UNITED STATES PATENT AND TRADEMARK OFFICE

APPLICATION NO.	FILING DATE	FIRST NAMED INVENTOR	ATTORNEY DOCKET NO.	CONFIRMATION NO.
10/759,733	01/20/2004	Phelan Richard	710P467DIV	6881

Office Action Summary

DETAILED ACTION

Replacement Sheet

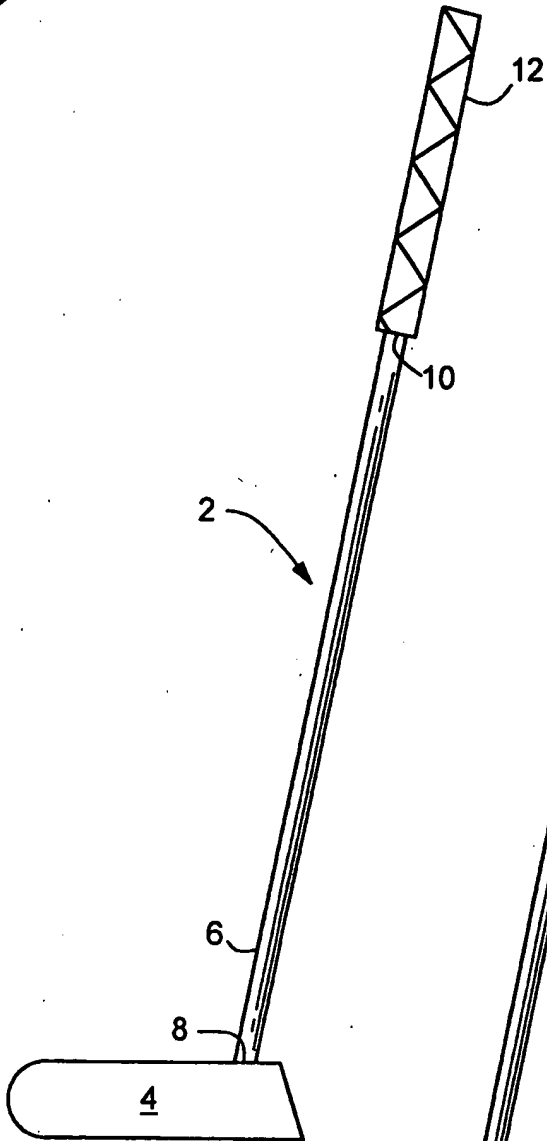
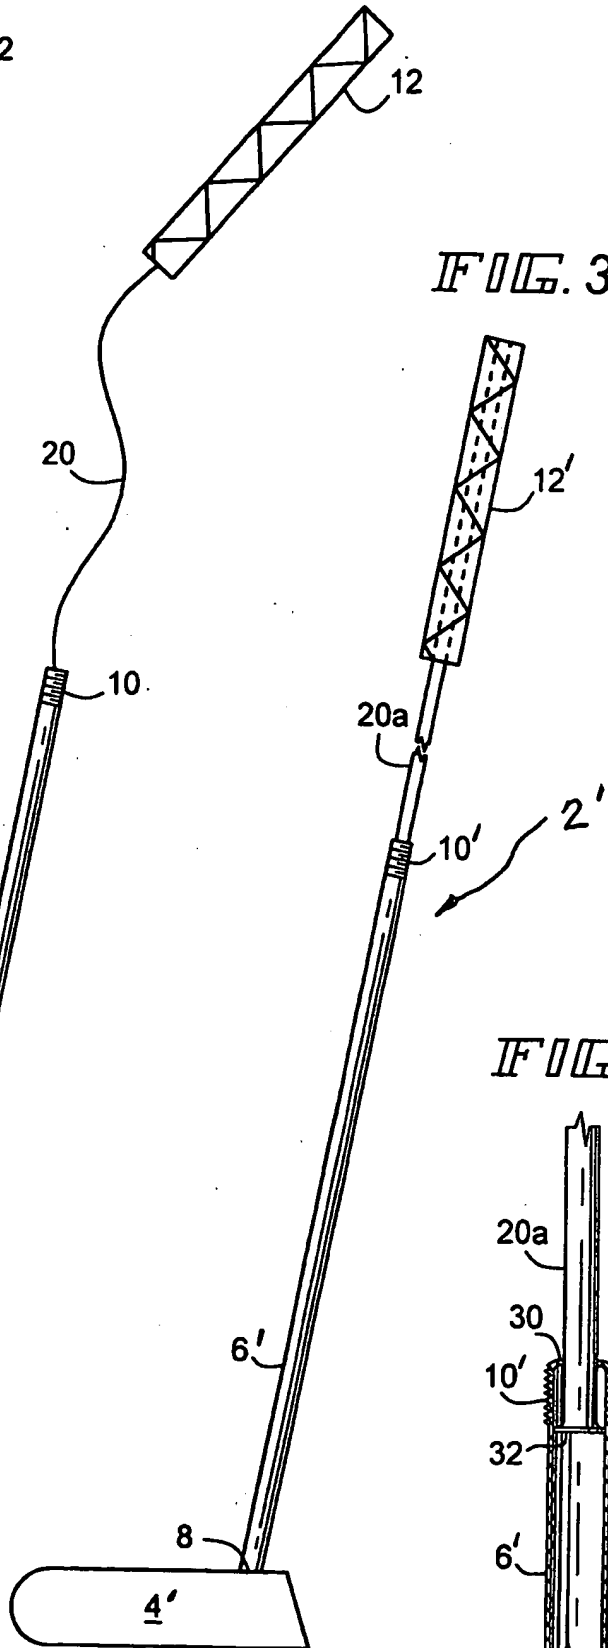
1. The replacement drawing sheet has been approved.

2. The disclosure stands objected to because of the following informalities:
 - a. On page 2 line 17 the number "14" does not make sense in that there is not reference number 14 in the drawings. The examiner recommends replacing the number "14" with the number --10 -- to correct this.
 - b. On page 2 line 18 the number "16" does not makes sense in that there is no reference number 16 in the drawings. The examiner recommends deleting the number "16" to correct this.

Approved Blen 8/29/06
